KCP&L - Greater Missouri Operations Company
Integrated Resource Plan
Case No. EE-2009-0237
Analysis of Renewable Energy Generation Screening and Integration
Final Report

The Missouri Department of Natural Resources

Robert Fagan

Synapse Energy Economics, Inc.

Wind Turbine Prices Are Softening, But Remain High By Historical Standards

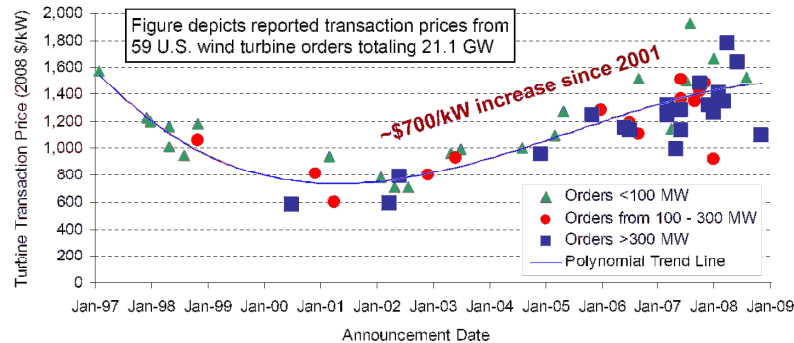
Though not shown in above graphic, spot turbine prices have softened as a result of the global recession and reversals in cost drivers, with 5-25% overall turbine price reductions seen through mid-2009

These figures illustrate that wind resource prices indeed began rising around 2005, but also reference the fact that “spot turbine prices have softened as a result of the global recession and reversals in cost drivers, with 5-25% overall turbine price reductions seen through mid-2009”. The “text” material available from the presentation contains the following description, made by the authors, of the relevant material in these presentation slides:

But we certainly have seen a softening in wind turbine pricing over the last several months, since late 2008. There's evidence of price decreases of even as much as 25% in turbines that are being sold in the U.S. market and internationally now relative to their peak in mid 2008.” [emphasis added]

When revising its IRP analysis, KCP&L-GMO should re-analyze the supply options using up-to-date wind resource prices and should take into account opportunities offered by the current period of market-depressed prices.

Uncertainties in Market Growth in Near-Term Reflect Balance Among Countering Trends

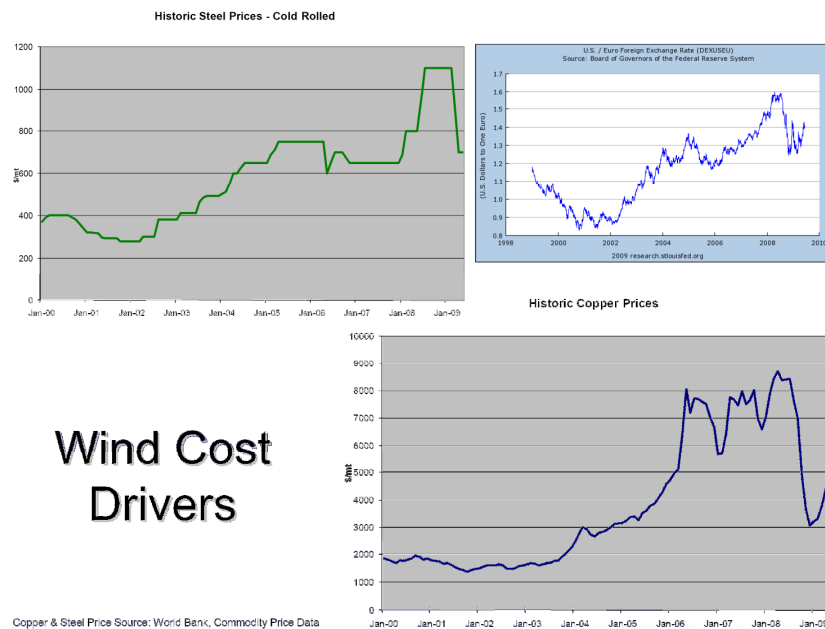
“There are expectations by many in the wind industry for further federal policy support whether that’s through a renewables portfolio standard, through climate policy or through transmission policy.

There are strong expectations that one or more of these kinds of programs will be enacted in the coming years during this administration. And finally we have dropping wind turbine prices. Prices have dropped perhaps as much as 25%, maybe a little less than that but on that order, over the last year or so.

And though those dropping turbine prices may not alleviate the price increase or the cost increase we'll see for installed projects built in 2009. Certainly those decreasing prices will flow through to project costs in 2010 and in future years.” [emphasis added]
